SAJ-2010-02881 Via Verde Pipeline Alignment (UNCLASSIFIED)

**Re: SAJ-2010-0881-IP-EWG-Via Verde Gas Pipeline
Final Project Shape Files and Alignment**

Re: Vía Verde Natural Gas Pipeline; SAJ-2010-02881 (IP-EWG)

Right of Way Diagram:

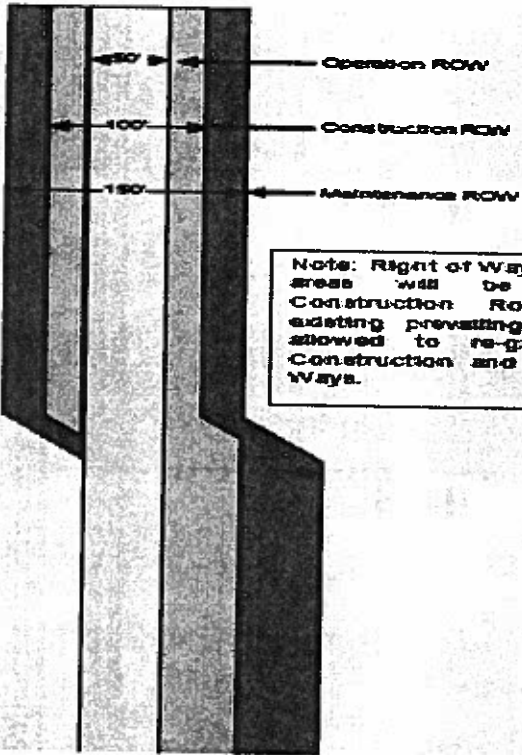
One additional remaining concern for EPA is the proposed project's right-of-way (ROW). At various times throughout the documents supplied by PREPA, the ROW is described as being 100, 150 or 50 feet wide. While the applicant has since explained the concept of a variable

ROW at the meetings to discuss outstanding project issues, we would appreciate a written, detailed explanation of this concept in order to include it in the project review file. If possible, PREPA should provide this information on a map, including the location of any staging areas or work platforms needed during construction. This information would help EPA determine whether there are any other issues that need to be addressed within the ROW in order to provide substantive comments to the Corps and PREPA.

One additional remaining concern for EPA is the proposed project's right-of-way (ROW). At various times throughout the documents supplied by PREPA, the ROW is described as being 100, 150 or 50 feet wide. While the applicant has since explained the concept of a variable ROW according to the activities being performed (construction, mitigation, maintenance, operation). The applicant's consultant has provided a brief description of the ROW categories, but we would appreciate a written, detailed explanation of the concept in order to include it in the project review file for future reference.

Via Verde Right of Way (RoW) as defined in the EIS as well as in the JPA considers three basic components defined as follows:

- Fifty (50) feet **Operation and Permanent RoW** where the pipeline will be buried. In this area, in particular within uplands, non deep rooted vegetation will be allowed to grow. In the case of Jurisdictional Areas, and once construction activities are completed, prevailing vegetation will be allowed to re-grow without any limitation, restoring the area to its original hydraulic and vegetative functions in a short period of time, (See Diagram included below)

- One hundred (100) feet **Construction RoW** to be utilized exclusively during the construction of the Via Verde project. Once construction activities are completed this area will be utilized as a Mitigation Area for the Planting of trees in uplands as required by the DNER. Within Jurisdictional Areas the RoW will be limited to 100 feet. After construction activities are completed, prevailing vegetation will be allowed to re-grow without any limitation, restoring the area to its original hydraulic and vegetative functions in a short period of time, (See Diagram included below)

- One Hundred and Fifty (150) feet **Maintenance RoW** which considers the above mentioned areas and provides an additional fifty (50) feet area of separation from any residential structures from the pipeline center line. Once construction activities are completed, it will be utilized as a Mitigation Area for the Planting of trees as required by the DNER. (See Diagram included below)

Note: Right of Way within jurisdictional area will be limited to the Construction ROW (100 ft) and existing prevailing vegetation will be allowed to re-grow on both the Construction and Operation Right of Ways.
